## ADDENDUM NO. 1

Project: Aurora Public Library District  
Eola Branch Rooftop Unit Replacement

Project No.: 22083

## REQUESTS FOR INTERPRETATION

### E5.0

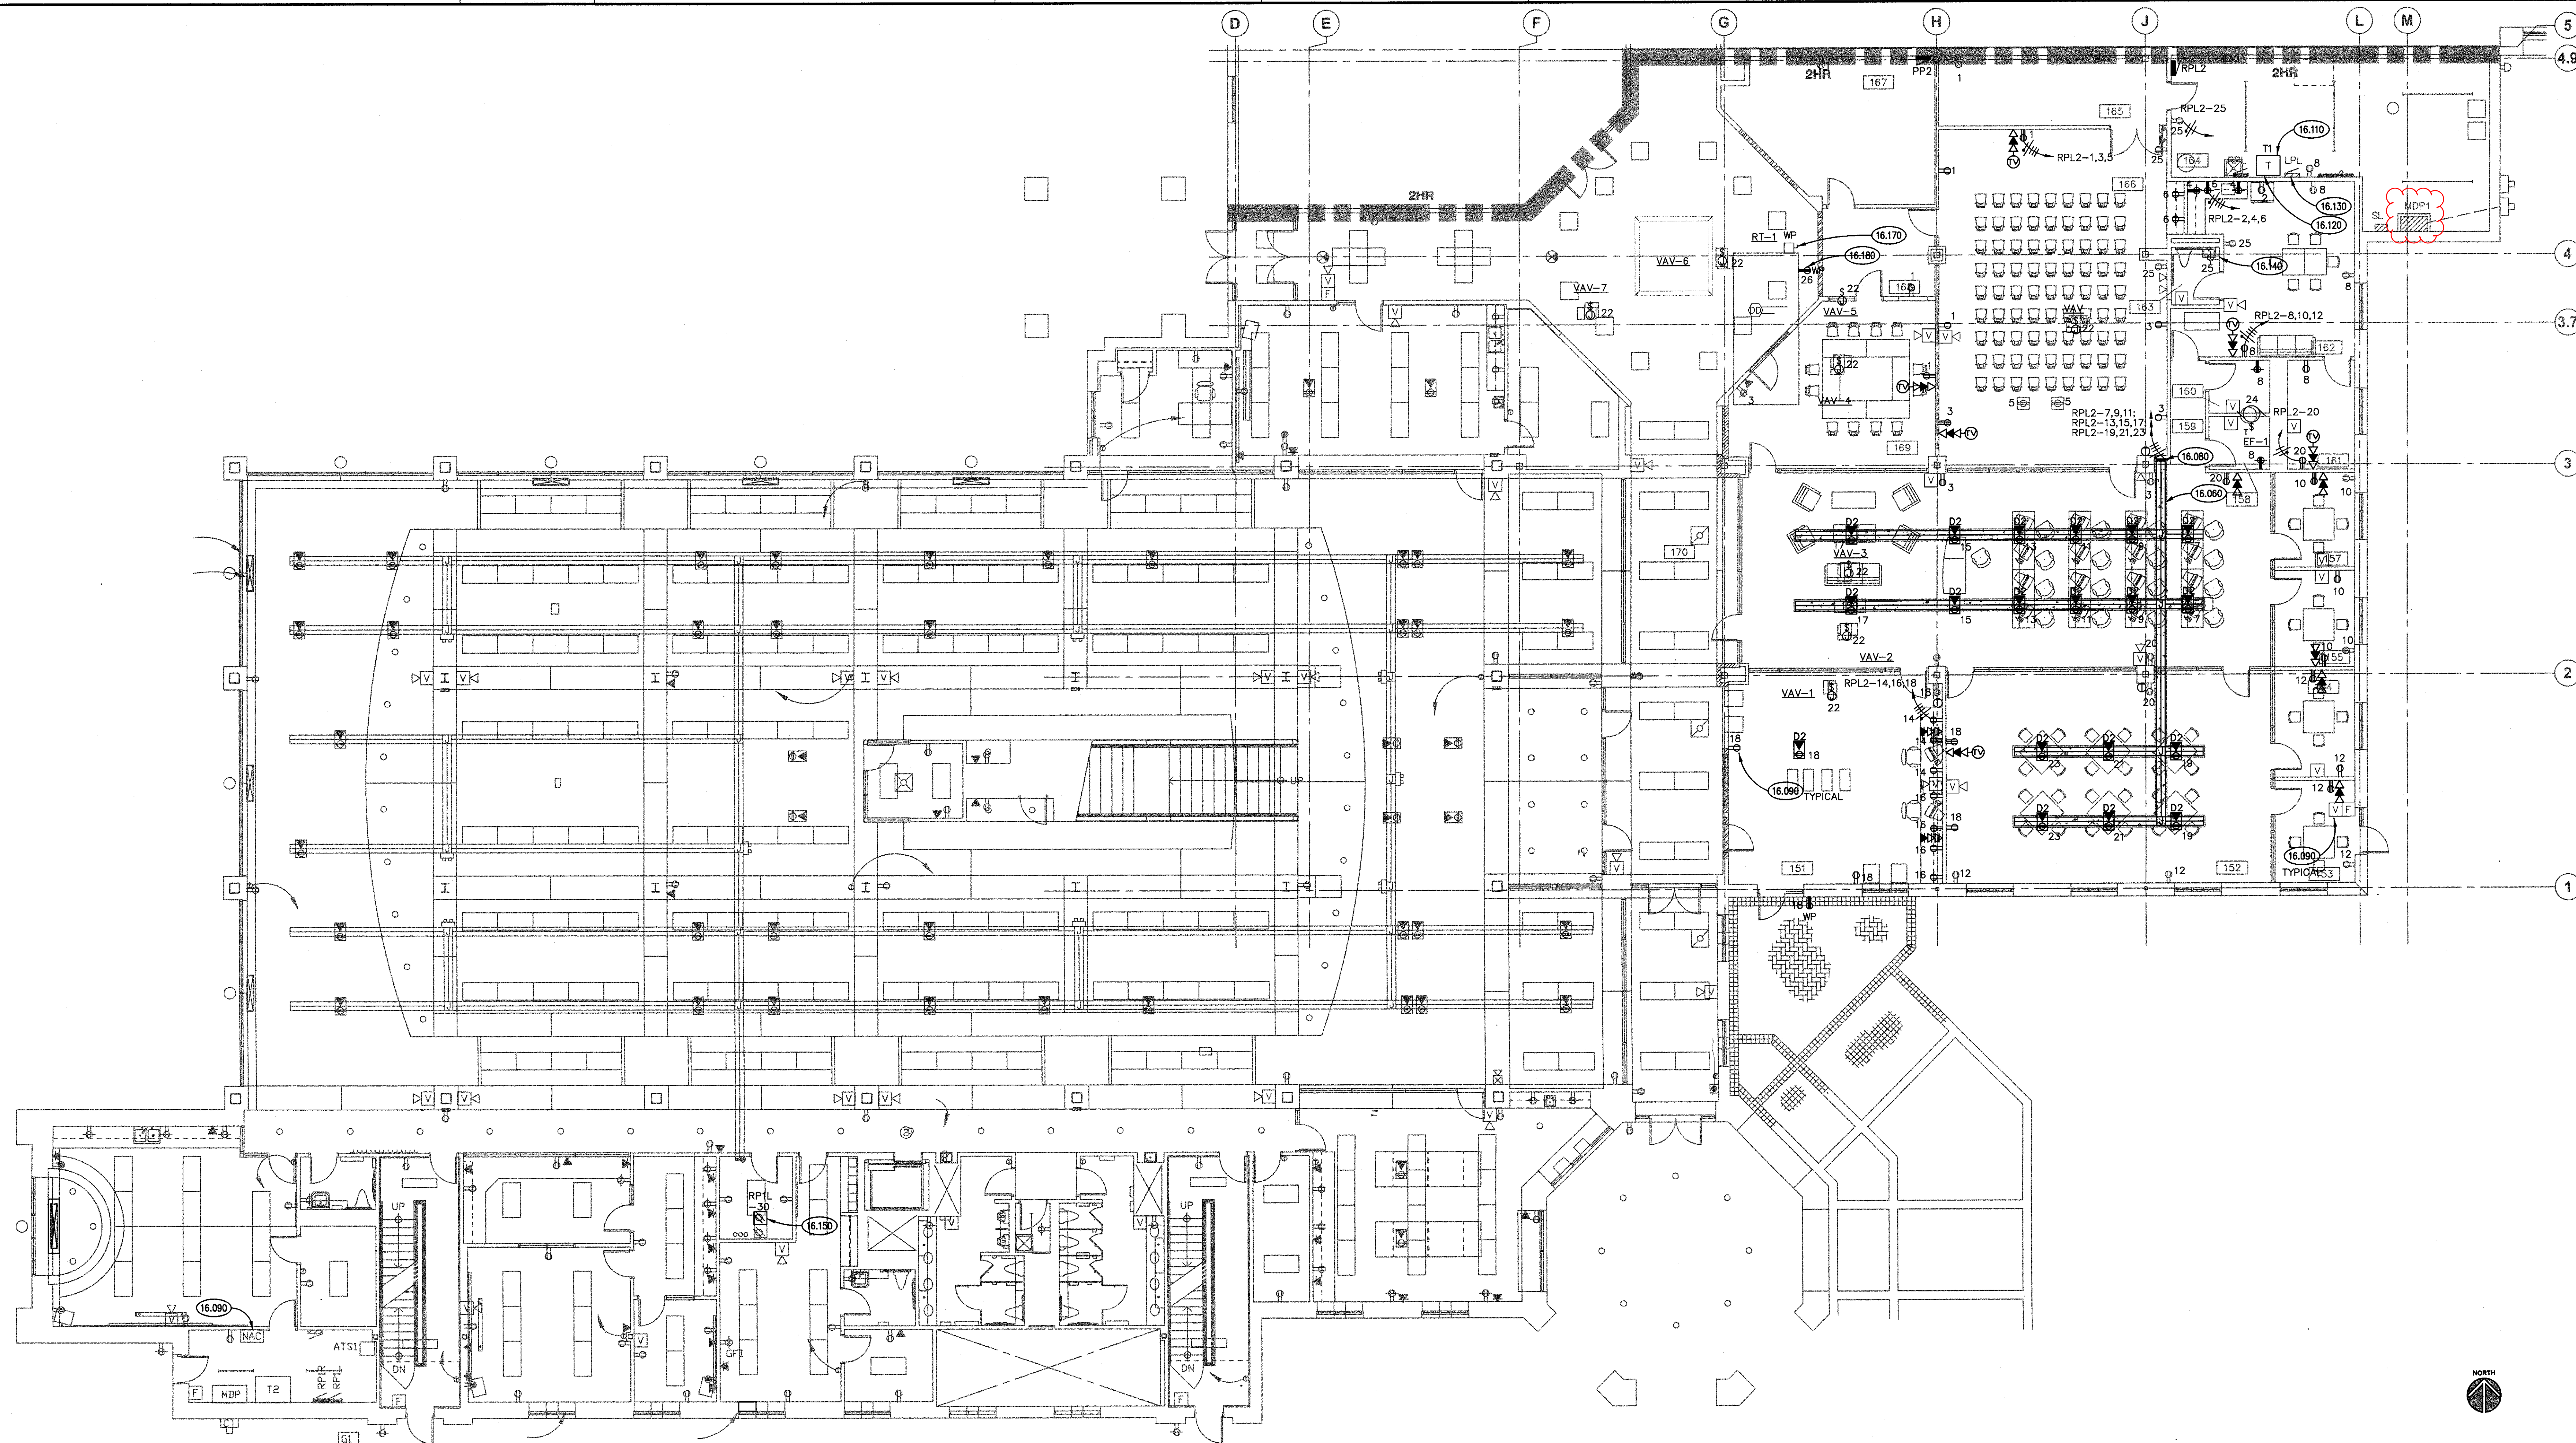
1. Would you be able to provide any information regarding electric panel or breaker locations?
  - a. Refer to attached annotated record drawings for breaker and panel information:
    - i. E3.1, E6.1 | Pages from Aurora Public Library – Eola Branch Addition 2006.pdf
    - ii. E3.1, E5.0 | Pages from Aurora Public Library – Eola Branch Addition 2001.pdf
